Proactive Environmental Protection Proforma

Contract No. HY/2014/07

Contract Title: Central Kowloon Route – Kai Tak West

Proactive Environmental Protection Proforma for Alternative Construction Method for Temporary Reclamation

Figure 2 – Proposed Scheme for Temporary Reclamation

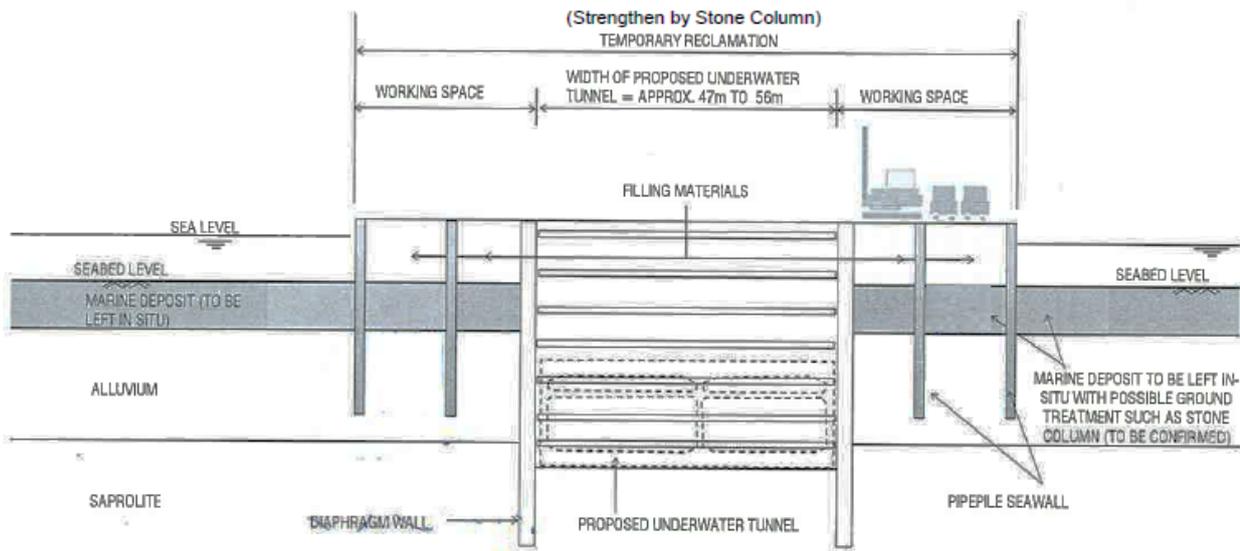
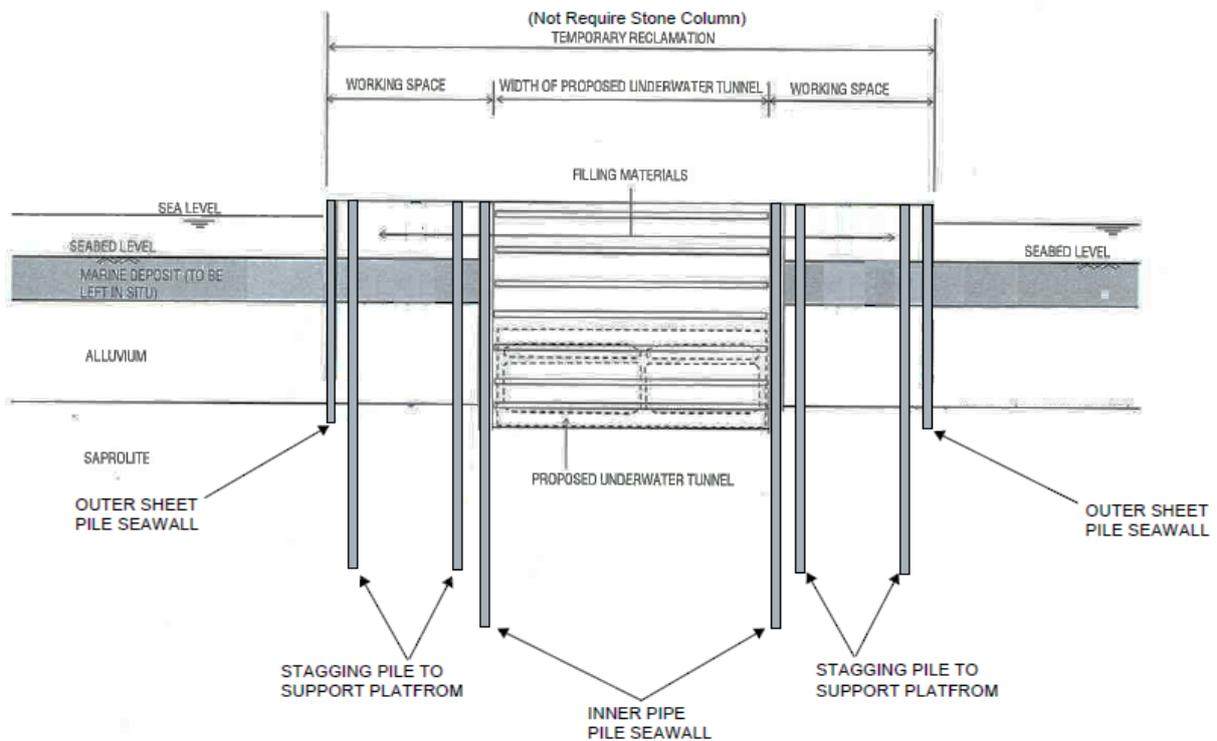
GCL proposes alternative construction method for the temporary reclamation. Instead of adopting ground treatment using the stone column, GCL proposes to erect prefabricated temporary steel deckings above seawater level in order to provide a dry working platform for constructional plants to be operated for forthcoming tunnel construction works. These temporary steel deckings will be mainly supported by staggings piles. Furthermore, the inner wall will be constructed using clutched pipe piles and no additional diaphragm wall is required in the proposed scheme.

In the proposed scheme, the construction does not involve ground treatment works, i.e. stone column installation is omitted. Instead of the ground treatment method, the staggings piles will be installed to support the steel deckings and will be constructed disturbing the seabed. A comparison on the volume of temporary seabed disturbance involved was made between the two schemes was estimated as attached in **Annex A**. Based on the estimation, minimal temporary seabed disturbance was anticipated in the proposed scheme. Similar to the original scheme, excavation of marine deposit under the temporary wall structure is not required.

During the construction of the temporary reclamation, silt curtain will be deployed to fully enclose the staggings pile construction.
